Access Compliance Report

Public Rights-of-Way

(Curb Ramps)

Intersection ID: 6204	Main Street: AMHERST_GLEN_DR	Cross Street: THOMASSON_PLACE_CR	Location: E
ADA ID: C2097ACB7E96	Ramp Type: Perp	Initial Pass/Fail: Fail	Overall Compliance: No
Severity Score: 22.5			
Codes/Mitigation Info/Possible Solution		Field Measurements/Component Compliance

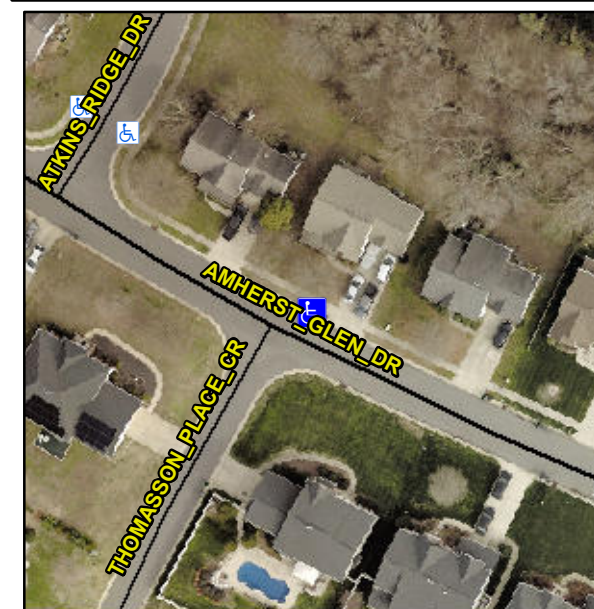
Not Found, R304.5.1, R304.2.2, R304.5.3

Compliance	Description	Data	Compliance	Description	Data
N/A	Ramp Length (in)	48.0	No	Ramp Slope (%)	10.8
No	Ramp Width (in)	44.0	No	Ramp XSlope (%)	3.6
N/A	Flare Type LT	N/A	N/A	Flare Type RT	N/A
N/A	Flare Slope LT (%)	N/A	N/A	Flare Slope RT (%)	N/A
N/A	Flare Traversable LT?	N/A	N/A	Flare Traversable RT?	N/A
N/A	Landing Length (in)	N/A	N/A	DWS Provided?	N/A
N/A	Landing Width (in)	N/A	N/A	DWS Contrast?	N/A
N/A	Landing Slope (%)	N/A	N/A	DWS Length (in)	N/A
N/A	Landing X Slope (%)	N/A	N/A	DWS Full Width?	N/A
N/A	Landing Curb? (Y/N)	N/A	N/A	DWS Offset (in)	N/A
N/A	Shared Landing?	N/A			
N/A	Gutter Ponding?	N/A	N/A	Gutter Slope (%)	N/A
N/A	Gutter Lip Ht (in)	0.5	N/A	Gutter X Slope (%)	N/A
N/A	Painted X Walk1?	No	N/A	Painted X Walk2?	N/A
	X Walk 1 Direction	To SW		X Walk 2 Direction	N/A
N/A	X Walk 1 Width (in)	N/A	N/A	X Walk 2 Width (in)	N/A
	X Walk 1 Slope (%)	3.6		X Walk 2 Slope (%)	N/A
	X Walk 1 X Slope (%)	2.0		X Walk 2 X Slope (%)	N/A

N/A	Ramp inside XWalk1?	N/A	N/A	Ramp inside XWalk2?	N/A
	Road Slope (%)	2.0	N/A	Clear Space?	N/A
	Road X Slope (%)	3.6	N/A	Clear Space to XWalk (in)	N/A
N/A	Any Obstructions?	N/A	N/A	Storm Grate/Utility Hazard?	N/A
	Obstruction Type			Storm Grate/Utility Type	
		N/A			N/A
			Yes	Surface Condition? (G/P)	Good

Possible Solutions:

Remove & Replace Entire Ramp.
